*Recommend denial or docketing for hearing.*

APPLICATION FOR CLASSIFICATION AS HARDSHIP GAS WELL

*Case 8579*

RE: San Juan 29-5 Unit #90

## PRODUCTION HISTORY

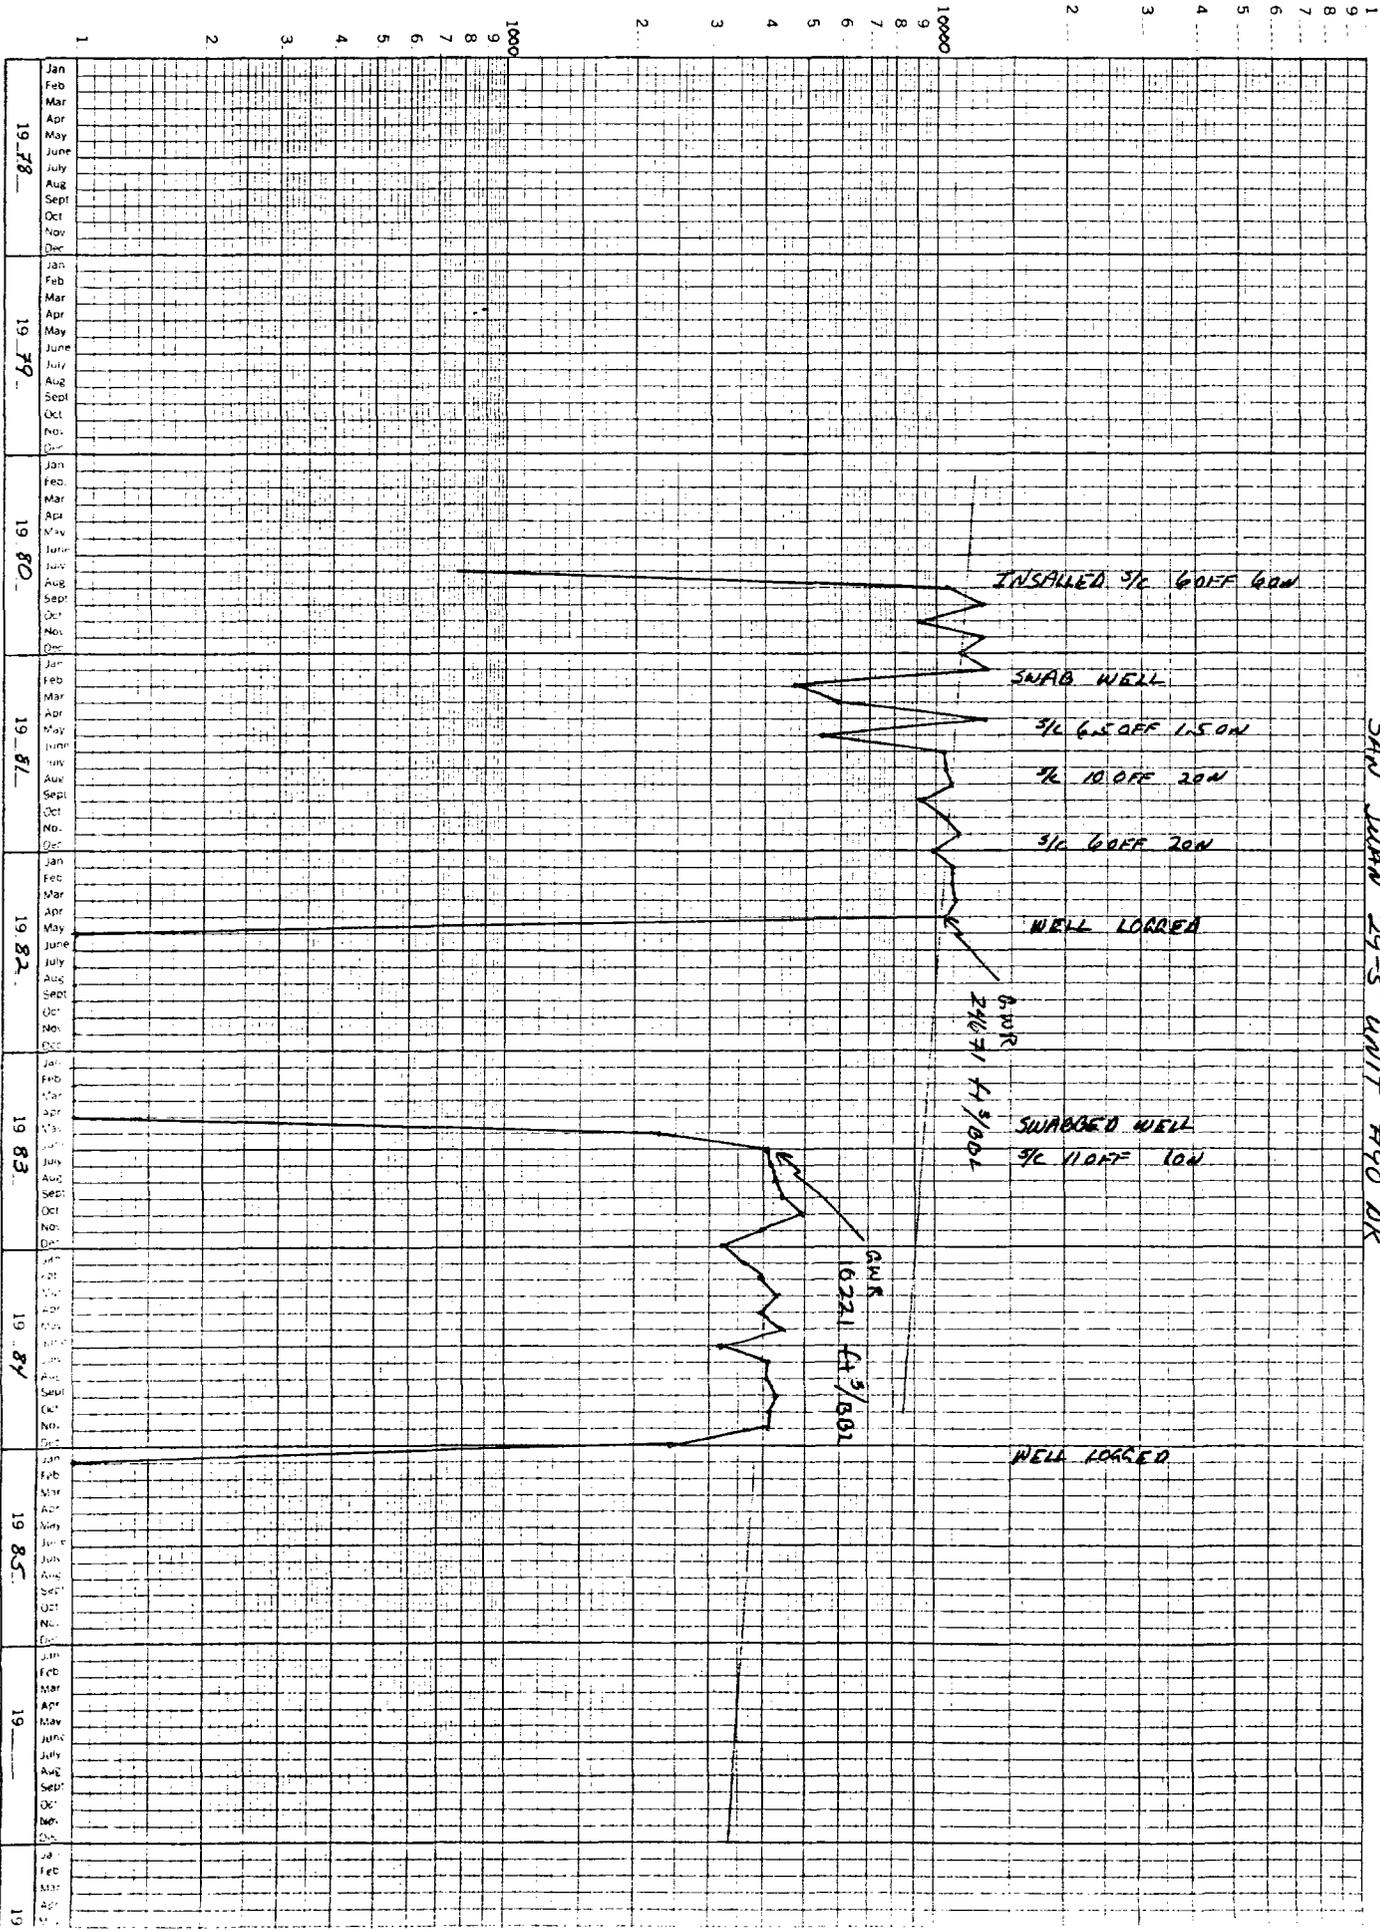
- ① Small bore tubing not run*
- ② No history of shut-ins*
